ADDRESS: 4370-74 MAIN ST

Proposal: Construct two-story addition

Review: In Concept

BACKGROUND:

2 PROPOSED REAR ELEVATION - SCHUYLKILL RIVER TRAIL
Scale: 1/4" = 1'-0"

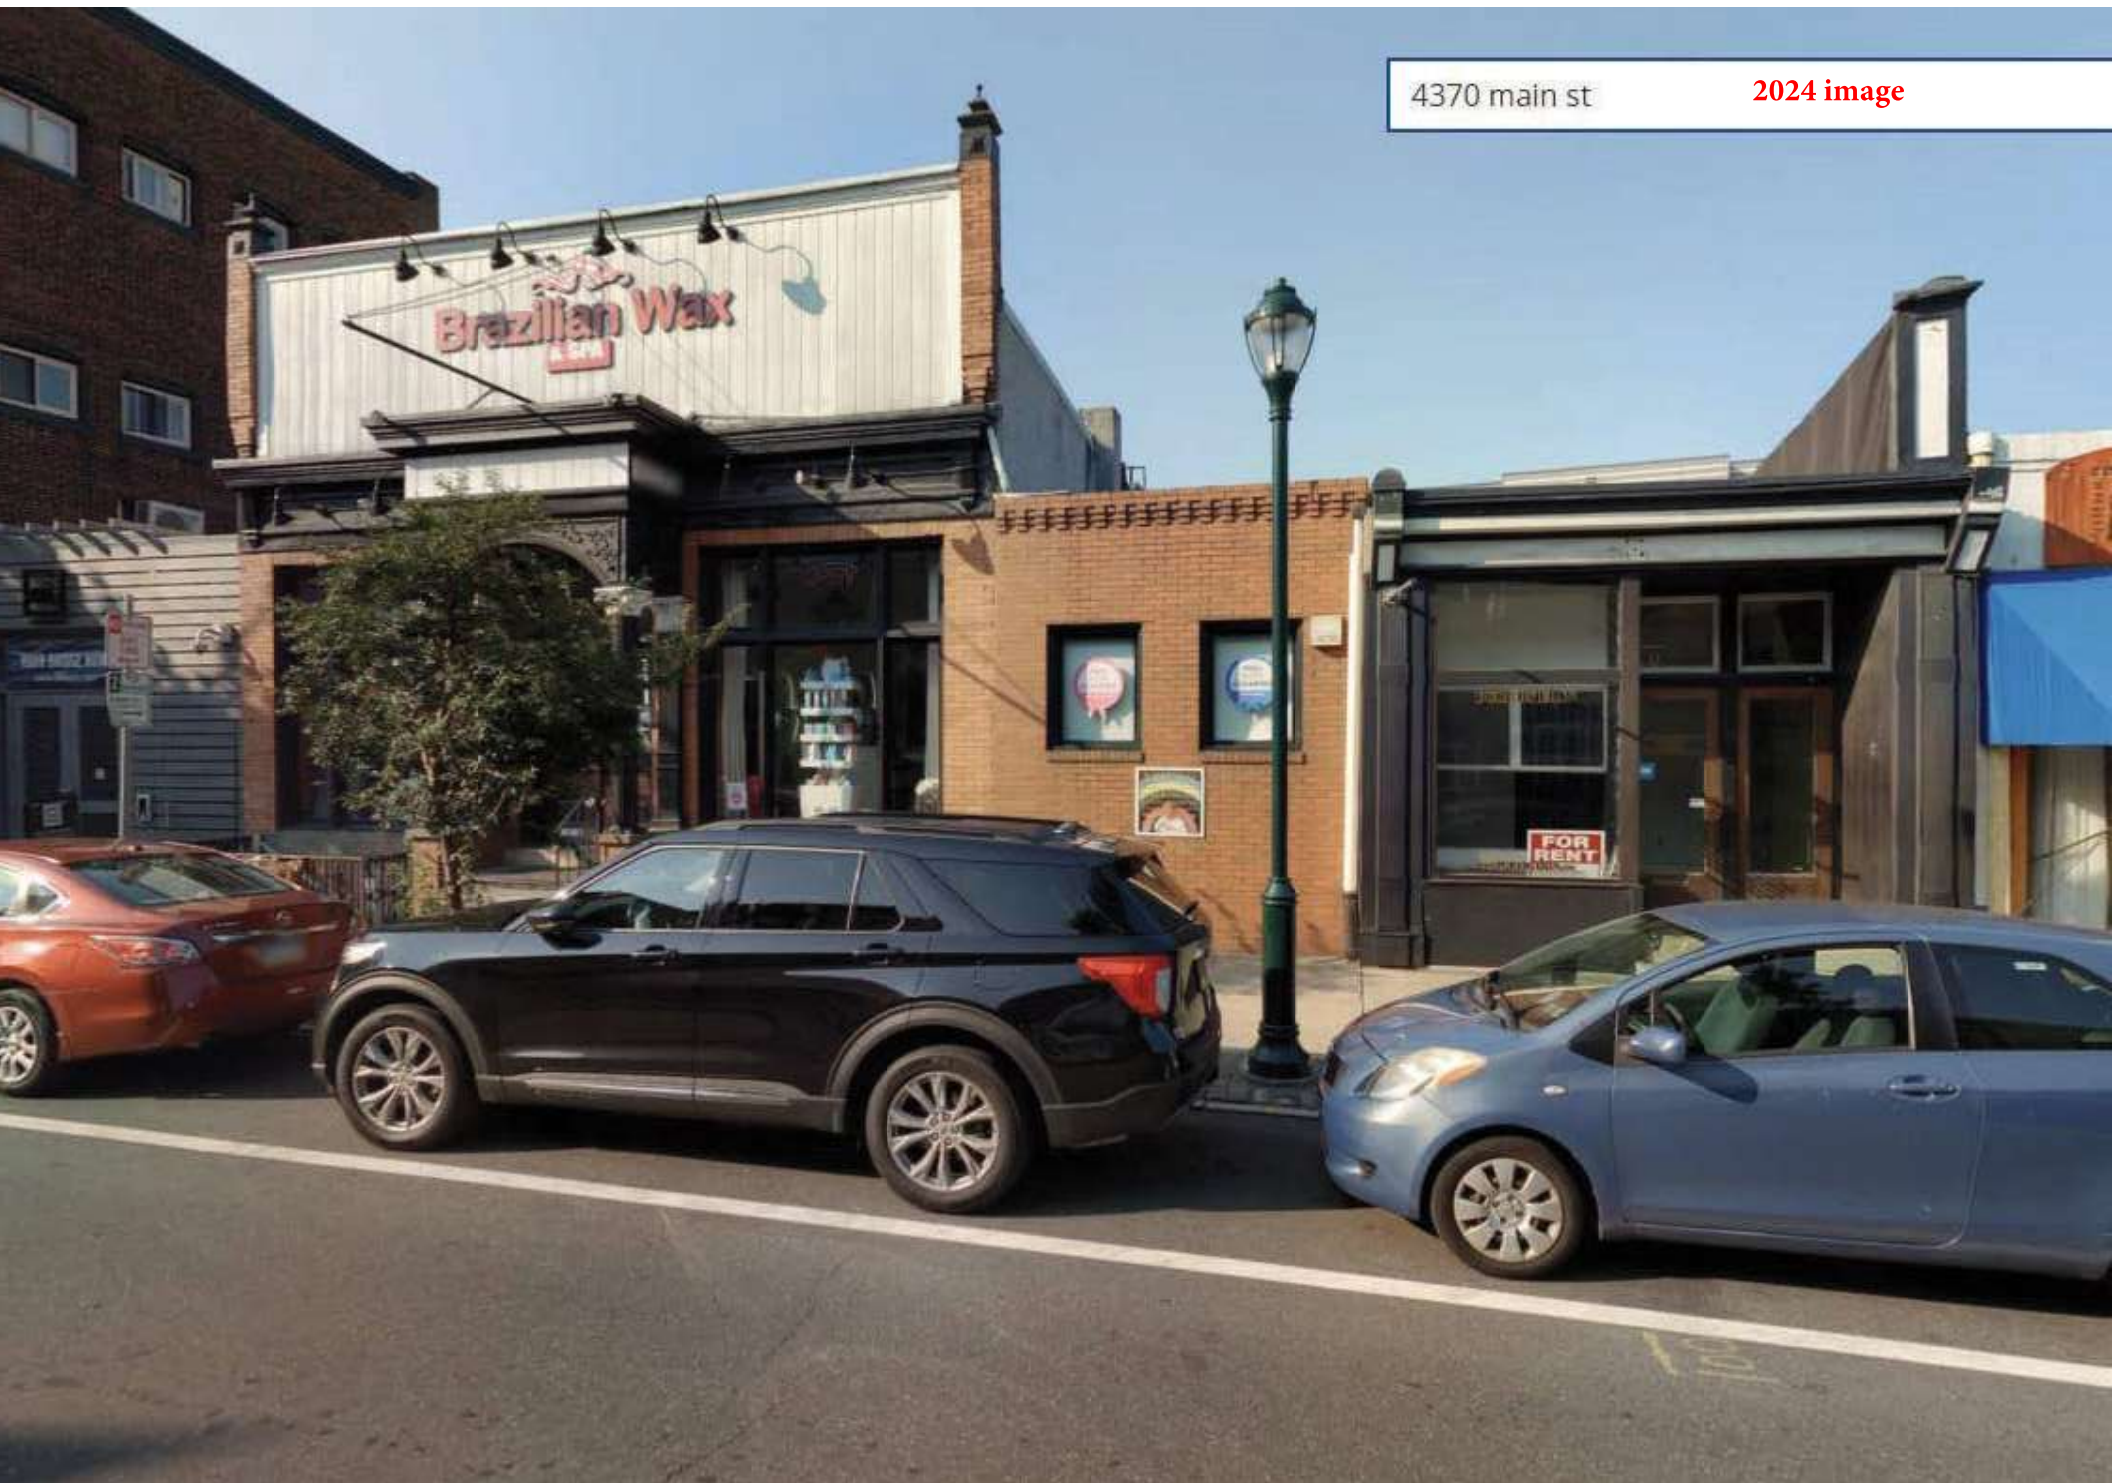
The building's rear faces the Schuylkill River Trail with substantial public visibility. The application generally retains the rear exterior as is but does not include details about any potential new windows or doors. The rear elevation of the new floors will include window openings that variably include one, two, or three windows immediately adjacent windows. Each floor will also have three Juliet balconies.

- Historically, the building served as commercial office space, while other properties in the Main Street Manayunk Historic District facing the river had

similar or industrial appearances in the rear. The proposed alterations to the existing rear façade may detract from the historic character of the district.

STAFF RECOMMENDATION: Approval of the overall size, massing, and general design of the proposed additions, but denial based on the need for additional details about materials, colors, finishes, and the proposed alterations to the rear façade, pursuant to Standards 2, 9, and 10, and Main Street Manayunk review criteria.

This application proposes to construct a two-story addition, to add six residential units, to 4370-74 Main Street, a one-story commercial property. The properties at 4370 and 4372-74 Main Street have been consolidated. The building at 4370 Main Street is classified as contributing to the Main Street Manayunk National Register Historic District while the buildings at 4372-74 classified as classified as "intrusions" in the district. Two floors would be added to the one-story combined building. The application does not propose any changes to the existing front façade of 4370 Main Street. The application does not specify how the large front parapet above the storefront would be incorporated into the addition.

- The proposal maintains the historic storefront's features, satisfying Standard 2, but the proposal lacks detail regarding how the addition interacts with the wall above the cornice on the front façade.

- *Standard 10: New additions and adjacent or related new construction will be undertaken in such a manner that, if removed in the future, the essential form and integrity of the historic property and its environment would be unimpaired.*
 - The proposed addition maintains the appearance of the front façade, though more detail on the interaction between the second-floor addition and front parapet on the contributing building is needed to determine if the application satisfies Standard 10.
